Access Compliance Report

Public Rights-of-Way

(Curb Ramps)

Intersection ID: 44907	Main Street: OAK_DR	Cross Street: OAKWINDS_CT	Location: NE
ADA ID: B9298749A3A4	Ramp Type: PerpDiag	Initial Pass/Fail: Fail	Overall Compliance: No
Codes/Mitigation Info/Possible Solution		Field Measurements/Component Compliance	
Severity Score: 58.75

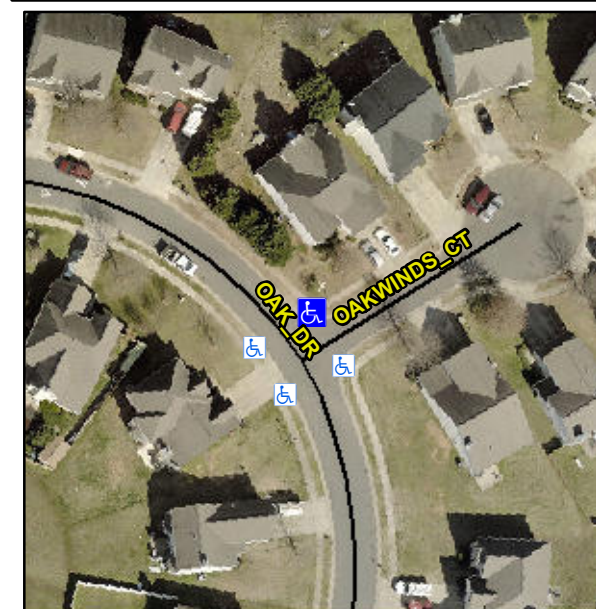
Not Found, R304.5.1, R304.2.2, R304.5.3

Compliance	Description	Data	Compliance	Description	Data
N/A	Ramp Length (in)	47.0	No	Ramp Slope (%)	20.0
No	Ramp Width (in)	36.0	No	Ramp XSlope (%)	9.9
N/A	Flare Type LT	N/A	N/A	Flare Type RT	N/A
N/A	Flare Slope LT (%)	N/A	N/A	Flare Slope RT (%)	N/A
N/A	Flare Traversable LT?	N/A	N/A	Flare Traversable RT?	N/A
N/A	Landing Length (in)	N/A	N/A	DWS Provided?	N/A
N/A	Landing Width (in)	N/A	N/A	DWS Contrast?	N/A
N/A	Landing Slope (%)	N/A	N/A	DWS Length (in)	N/A
N/A	Landing X Slope (%)	N/A	N/A	DWS Full Width?	N/A
N/A	Landing Curb? (Y/N)	N/A	N/A	DWS Offset (in)	N/A
N/A	Shared Landing?	N/A			
N/A	Gutter Ponding?	N/A	N/A	Gutter Slope (%)	N/A
N/A	Gutter Lip Ht (in)	N/A	N/A	Gutter X Slope (%)	N/A
N/A	Painted X Walk1?	No	N/A	Painted X Walk2?	No
	X Walk 1 Direction	To SW		X Walk 2 Direction	To SE
N/A	X Walk 1 Width (in)	N/A	N/A	X Walk 2 Width (in)	N/A
	X Walk 1 Slope (%)	4.5		X Walk 2 Slope (%)	2.4
	X Walk 1 X Slope (%)	6.0		X Walk 2 X Slope (%)	7.4

Remove & Replace Curb Ramp With Two New Directional Ramps or Equivalent.
